# SINGLE ENGINE CUSTOMER CARE SERVICE INFORMATION LETTER

SE80-3

SUBJECT: DOOR POST MAPLIGHT SWITCH INSULATOR

AIRCRAFT APPLICABILITY: 1977 and on Model 172 and R172  
1975 and on FR172  
(See Remarks for specific serials)

#### INSTALLATION OF SWITCH INSULATOR - DOORPOST MOUNTED MAPLIGHT

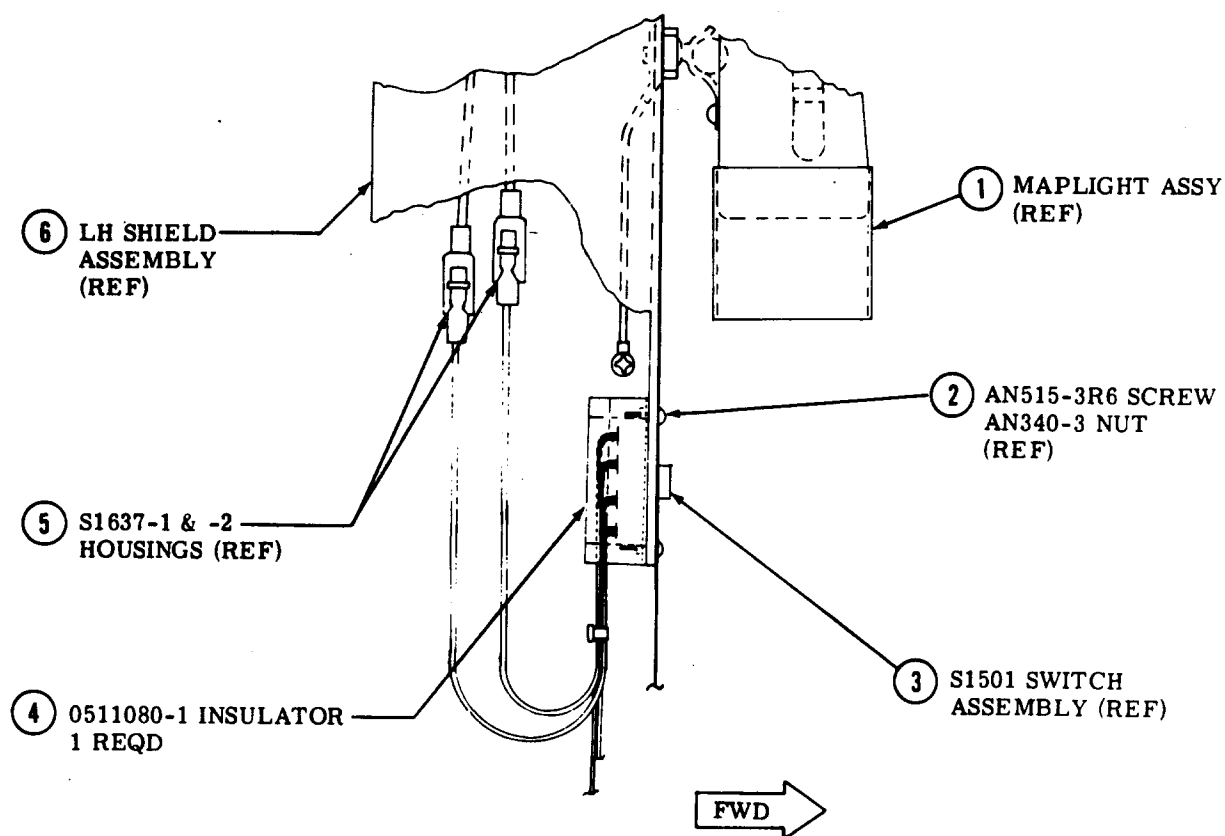
A protective insulator on the door post maplight switch is now being installed on production aircraft.

This switch insulator (Part Number 0511080-1) provides improved coverage over the switch terminals.

1. Remove shield assembly (6) from doorpost far enough to gain access to switch assembly (3).
2. Loosen screws and nuts (2) enough to slip the slotted ends of the insulator (4) under the switch assembly (3), between the switch and shield assembly.
3. Secure switch assembly (3) and insulator (4) to shield assembly (6) with screws and nuts (2).
4. Reinstall shield assembly and check maplight for proper operation.
